SUBJECT: Transmittal of Revised Westinghouse Proprietary and Non-Proprietary Responses to U.S. Nuclear Regulatory Commission Requests for Additional for the AP1000 Application for Design Certification

Westinghouse Revised Non-Proprietary Responses
to US Nuclear Regulatory Commission
Requests for Additional Information
dated March 17, 2003

AP1000 DESIGN CERTIFICATION REVIEW

Figure 440.151-1-2

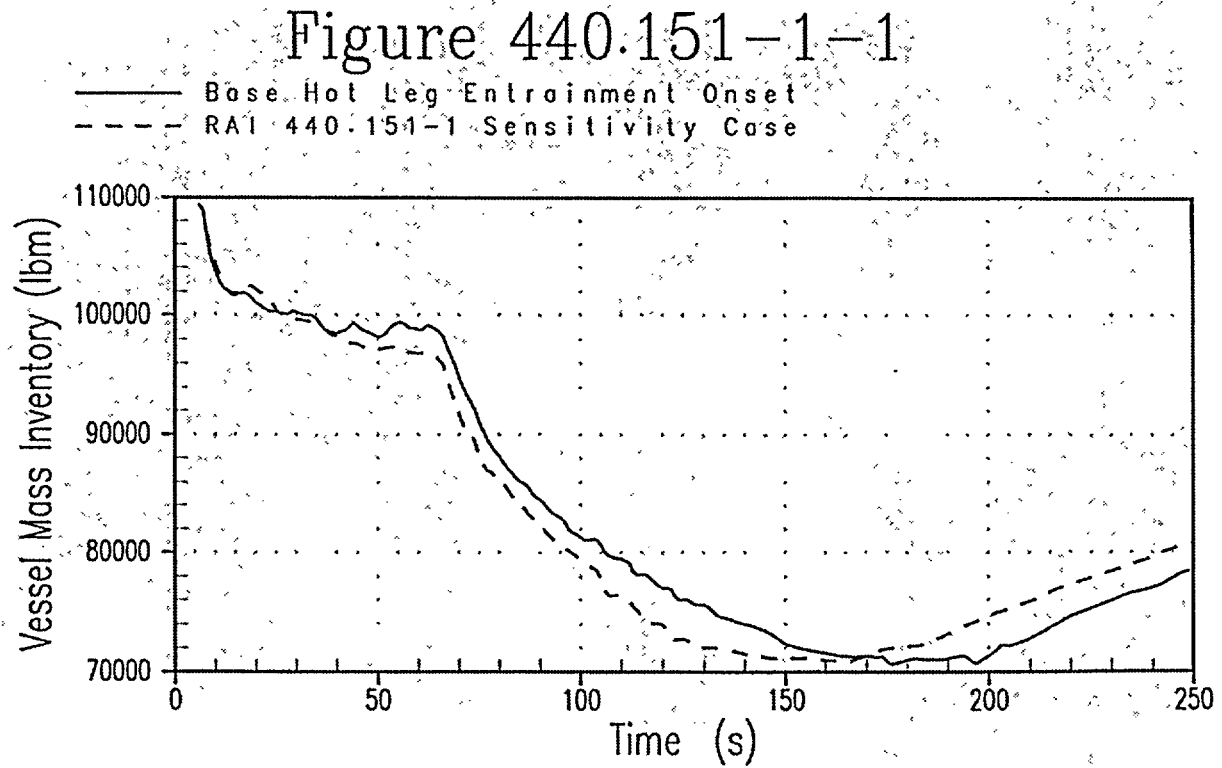
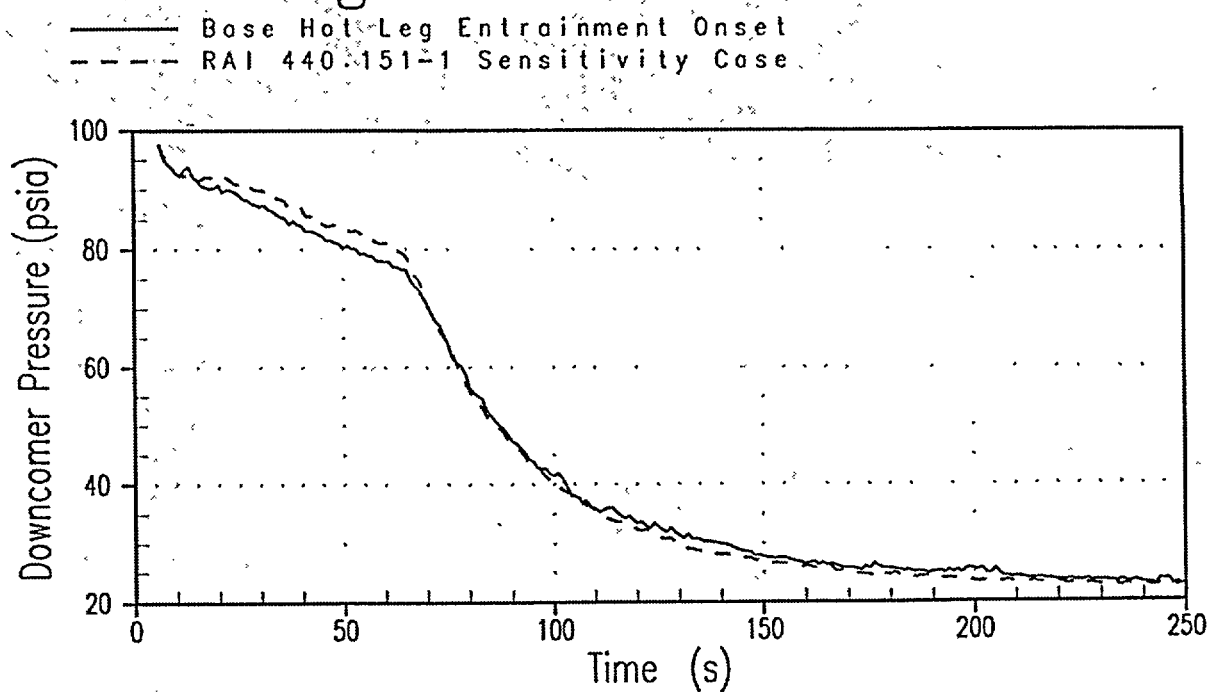
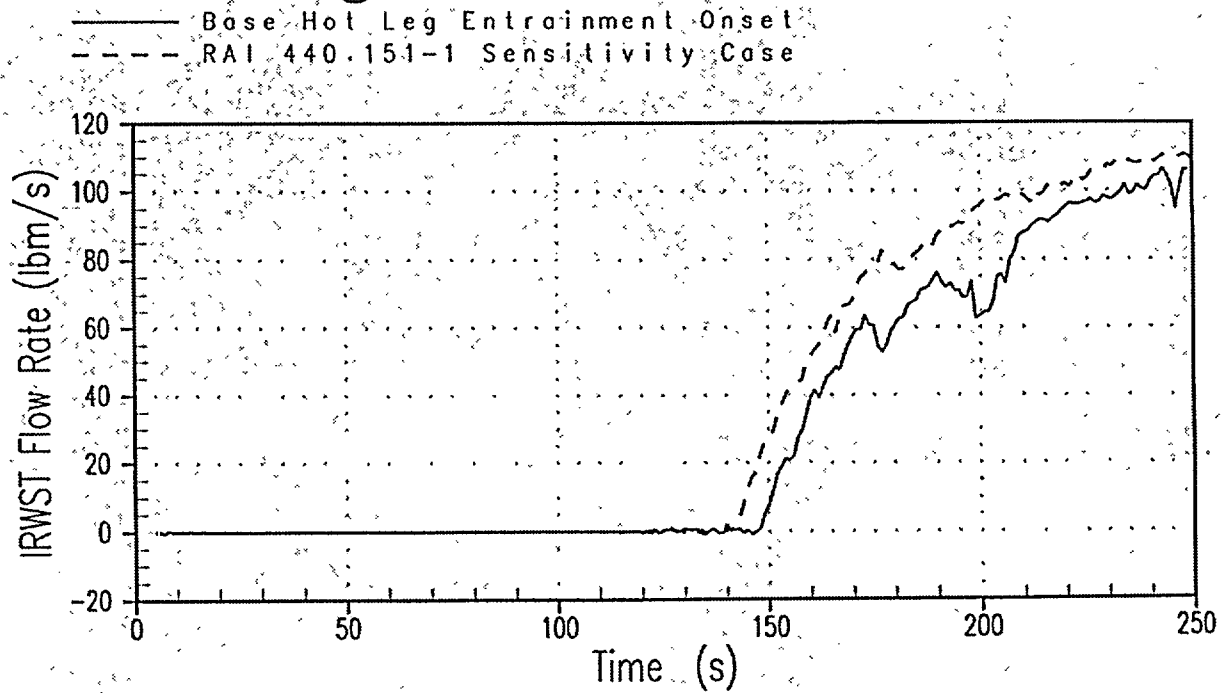
- (1) Augment the WCOBRA/TRAC-AP sensitivity study on hot leg entrainment onset by providing an additional case in which the models are biased to predict the very low branch line flow qualities suggested by the ATLATS data. The Westinghouse case would be acceptable if the delay in IRWST remains small.
- (2) The scaling rationale presented on pages 4-38 and 4-39 of WCAP-15613 should be revised to make use of the onset correlation by Welter, K. B., Wu, Q., Yao, Y., and Reyes, J. N., "New Model for Predicting Two-Phase Entrainment Rates in Tees," ANS Trans., Winter Annual Meeting, Washington DC, 2002. Their onset correlation, which is based on ATLATS data and thus presumably embeds the effect of hot leg flow pattern, is given by:

WCAP-15833, Rev. 2 provides a sensitivity study to the hot leg entrainment onset in Section A.4.4. Three cases are presented in which either coefficient C1 or C2 in the Froude number expression shown above in the additional comment section is varied from its base value. Within the WCOBRA/TRAC computer code, when either coefficient is varied the predicted branch line quality is also varied according to Equation(1) in the RAI statement.

The two coefficients can be manipulated together to obtain a very low branch line quality comparable to that of the Figure 1 ATLATS test data. Figure 2 (shown in the RAI 440.154 RAI statement) plots the ATLATS branch line quality data as a function of Froude number together with the AP1000 values calculated for the C1 and C2 values analyzed in Section A.4.4 of WCAP-15833, Rev. 2. Branch line qualities in the range of the ATLATS data can be obtained by further adjustments of the C1 and C2 coefficients. Specifically, at a Froude number of 2.0, applying C1 and C2 values of 0.10 and 2.0, respectively, predicts a branch line quality of 0.065 in RAI 440.154, Figure 2. The impact of these coefficient values on predicted behavior during the AP1000 ADS-4 IRWST initiation phase has been determined by performing another WCOBRA/TRAC sensitivity run for the Inadvertent ADS actuation scenario. The results are compared with the base hot leg entrainment onset case in the attached figures. The net result of the sensitivity case is the release of more mass through the ADS-4 flow paths early in the depressurization at a higher pressure, which results in less mass present in the upper plenum and hot legs at lower pressures. During the initial portion of the depressurization transient, added mass is released through the ADS-4 flow paths, and the reactor vessel and upper plenum mass is lower than in the base case, as shown in Figure 440.151-1-1. The lower mass present in the upper plenum leads in turn to a lower flow of entrained liquid into the hot legs beyond 100 seconds, so more effective depressurization occurs (Figure 440.151-1-2). The venting of steam as the pressure approaches IRWST actuation pressure through the ADS-4 paths is more effective, and IRWST injection begins slightly earlier in the sensitivity case, as shown in Figure 440.151-1-3.

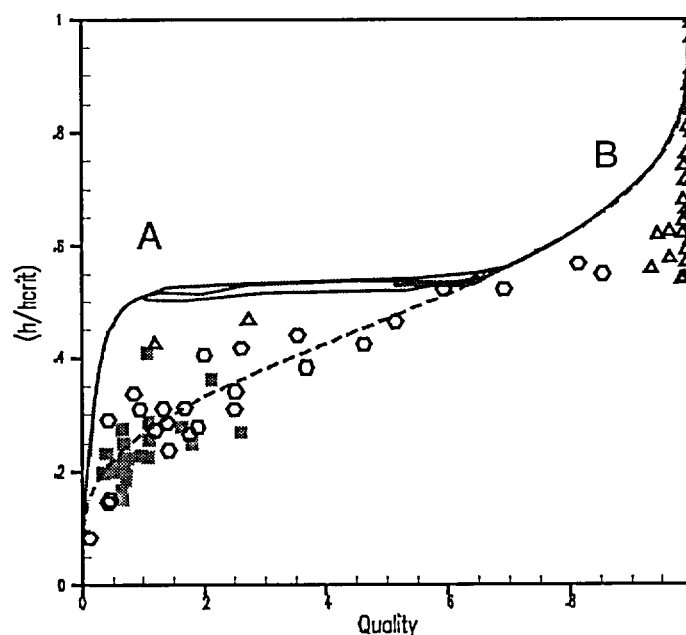
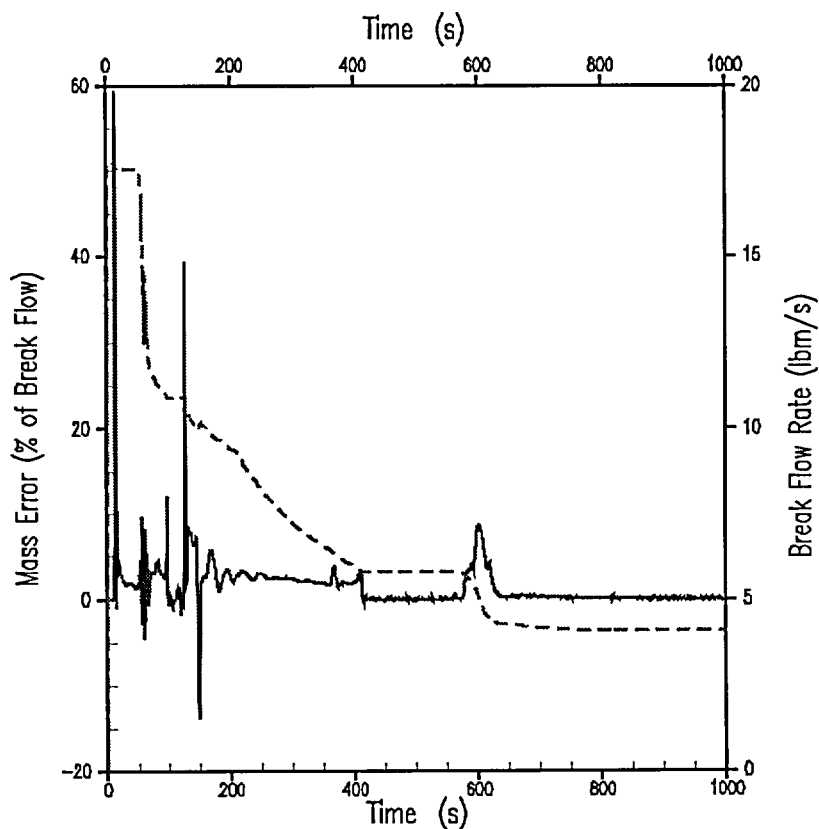
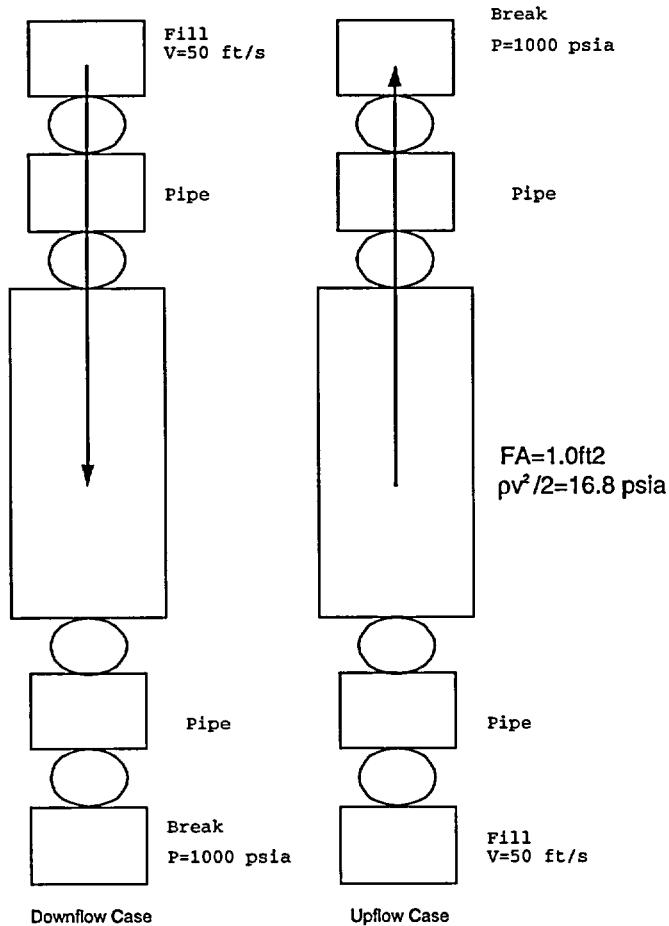
Response supplied is not sufficient. Additional information is needed to describe what the code does when the quality predicted by an offtake expression does not correspond to the quality (inferred from the void fraction) in the top cell of the Channel in the hot leg where the branch line connects. For example, if there are insufficient droplets in the top cell to satisfy the branch line quality demand, where does the "extra" liquid get extracted from ? Are mass and momentum conserved as implemented?

In the figure below, h is the distance between the break elevation and the stratified surface. H_{crit} is the distance at which the entrainment begins. The comparison plot indicates that more liquid is predicted to entrain when the liquid level is close to the top of main pipe than was observed in the experiment and also the correlation (Point A).

Mass balance is checked in one of TPFL test with the horizontal connection in the figure below. The mass balance across the 1D/3D connection was checked by taking the difference between the summation of adjacent gap flows and the 1D component break flow. This ignores the storage term in the volume of the channel connected to the 1D. By ignoring the storage term, the apparent mass balance is contaminated when the junction cells are either depleting or accumulating liquid, as in the time periods between 0-400 seconds, and 600-650 seconds in the attached figure. In the quasi-steady state time periods, the mass balance error is essentially zero.

To examine the momentum convection scheme, a simple vertical channel/pipe model with $FA=1\text{ft}^2$, $\Delta X=1\text{ft}$ was constructed as seen in the left figure.

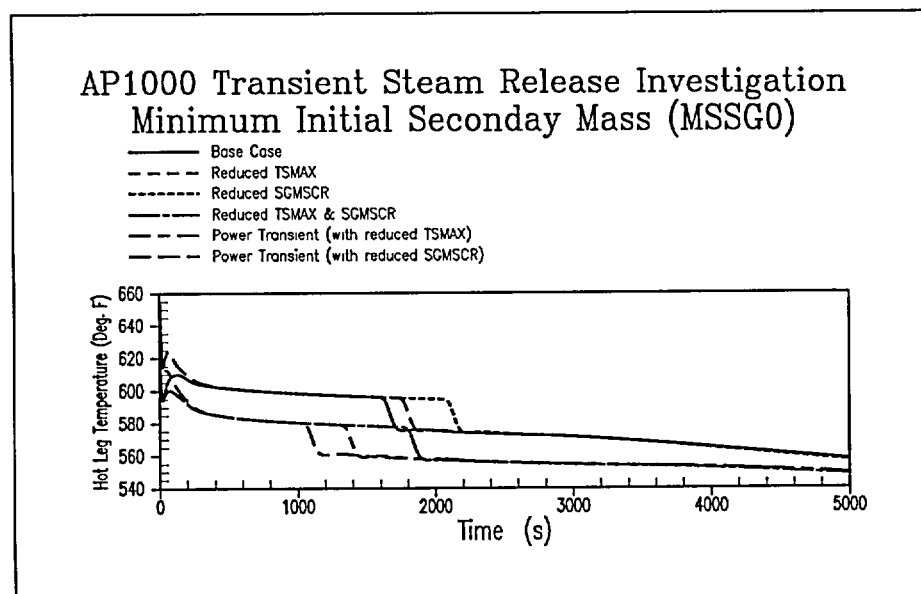
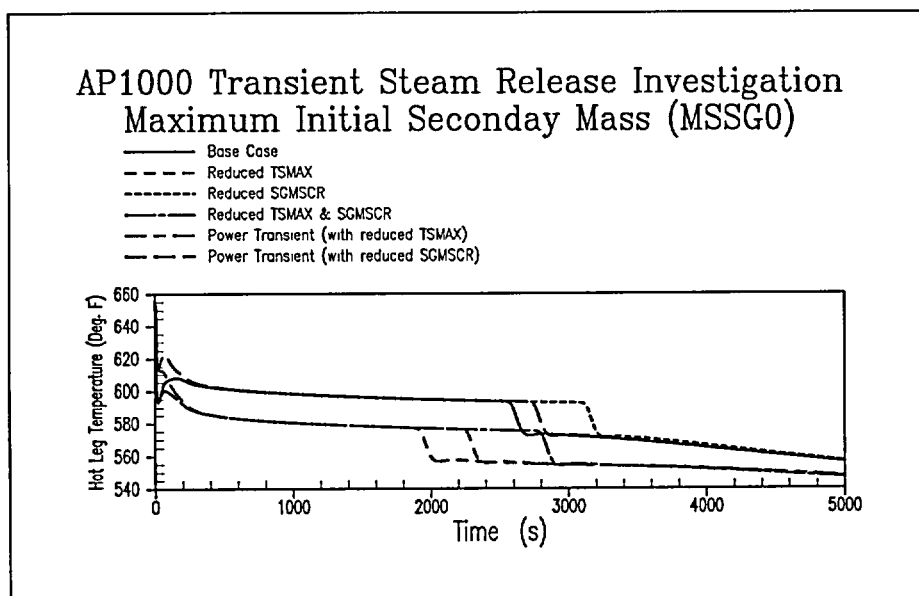
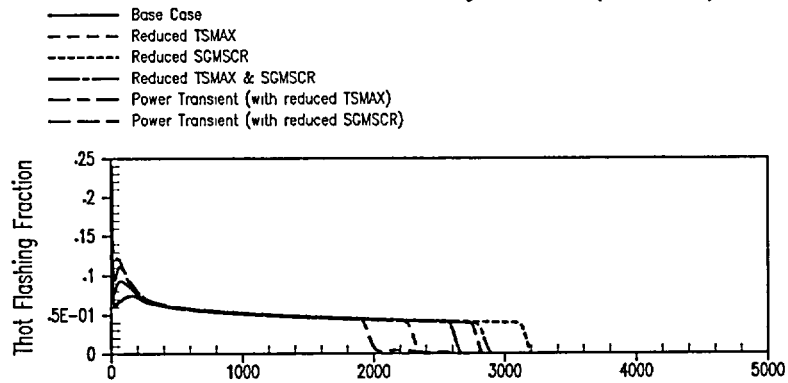
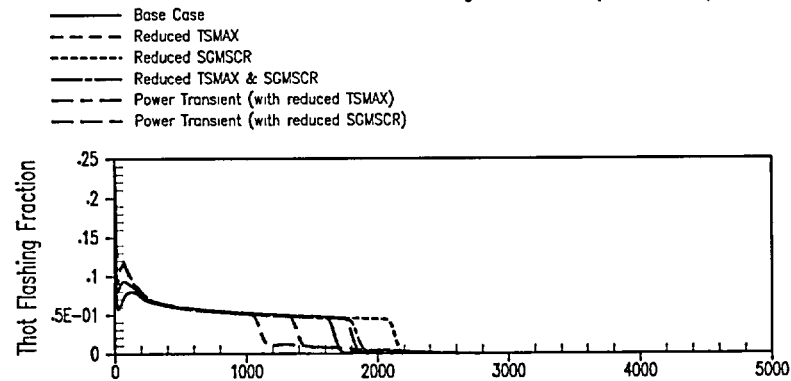
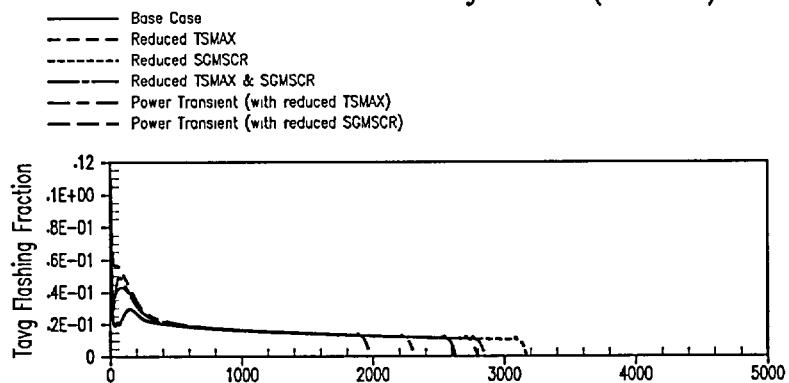
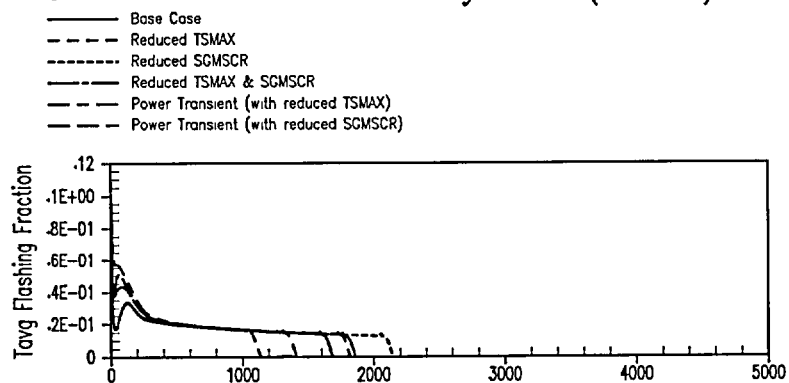
- D. What is the basis for the leak flashing fraction of 0.04% for the first 60 minutes of the LRA?
- E. Table 15.3-3 lists the reactor coolant noble gas activity as equal to the operating limit of 280 milliCi/gm (milli-Curies-per-gram) dose equivalent Xe-133. Other accidents list this operating limit as 280 microCi/gm dose equivalent Xe-133. Please clarify the discrepancy (is this a typographical error)?

The reactor coolant temperatures following the locked rotor were used together with the secondary pressure to calculate the flashing fraction. This flash fraction was determined on a time dependent basis using a constant enthalpy process based on enthalpy of the primary coolant in the steam generator tubes, the enthalpy of liquid water at saturation, the time dependent enthalpy conditions at the secondary side pressure, and the heat of vaporization at the secondary side pressure. It is generally assumed that the primary to secondary leakage is distributed throughout the tube bundle and a flashing fraction based on the average temperature of the hot and cold legs is justified. However, since this is a critical parameter for the dose analyses, and the actual location of the leak(s) is unknown, a conservative flashing fraction skewed towards the hot leg temperature was used.

The LOFTRAN model was used to calculate the transient reactor coolant system temperatures and secondary side pressures following a postulated locked rotor event. The transient models the reactor trip with subsequent loss of offsite power. Main feedwater is lost and no startup feedwater is provided. Decay heat removal occurs through the steam generators. As secondary mass is lost due to steaming, PRHR actuation occurs on low steam generator level. Eventually the PRHR is removing all decay heat and heat transfer to the steam generators, and steam release stops. Sensitivity cases were run to investigate the impact of parameters which potentially impact the results being investigated, including: the initial secondary side mass, the steam generator safety valve setpoint, the PRHR actuation setpoint, and an initial power excursion. Bounding values were developed based on the results.

The time dependant flashing fraction was calculated assuming all leakage was at the temperature of the hot leg and a bounding average flashing fraction of 0.055 was established. The calculation was repeated assuming that all leakage was at the average of the hot and cold leg temperatures, and a bounding average flashing fraction of 0.025 was established. For the dose analysis these two values were averaged to a flashing fraction of 0.04.

AP1000 Transient Flashing Fraction Investigation

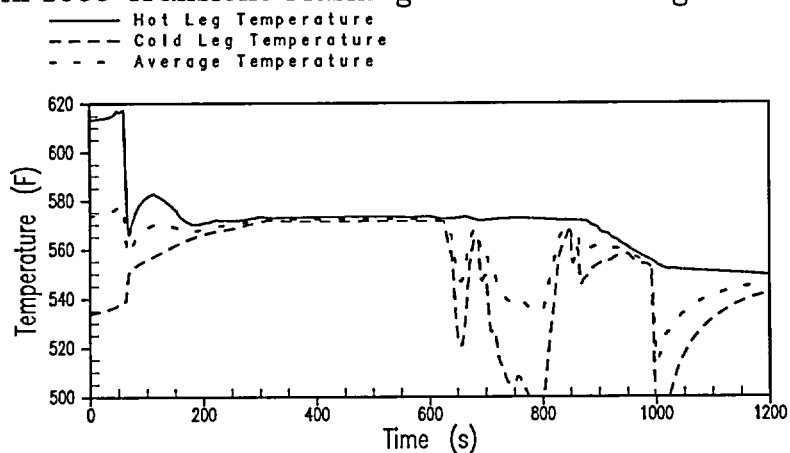
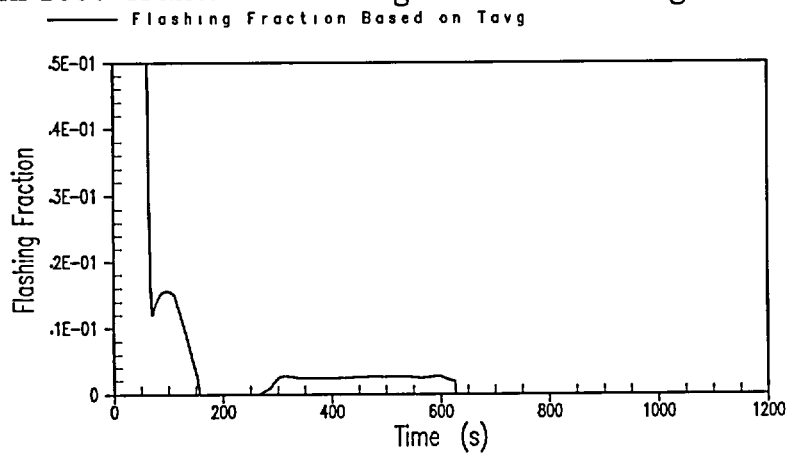
Figure 15.6.5.4B-17 of the DCD shows the primary pressure transient for the SBLOCA. The steam generator pressure is maintained at the safety valve setpoint until the reverse heat transfer to the primary system starts when the primary pressure falls below the secondary pressure. From Figure 15.6.5.4B-17 the primary pressure is below the secondary pressure well before the 1800 seconds assumed in the radiological consequences analysis.

Figure 15.6.5.4B-17 of the DCD shows the primary pressure transient for the SBLOCA. The corresponding reactor coolant system temperatures and secondary pressure were obtained for use in calculating the flashing fraction. The figures below provide the reactor coolant temperatures and the corresponding calculated flashing fraction based on the average reactor coolant temperature. The bounding flashing fraction of 0.04 was initially selected based on preliminary analysis results and retained even though the DCD analysis indicates that a lower flashing fraction is justified. This background information is not included in the DCD.
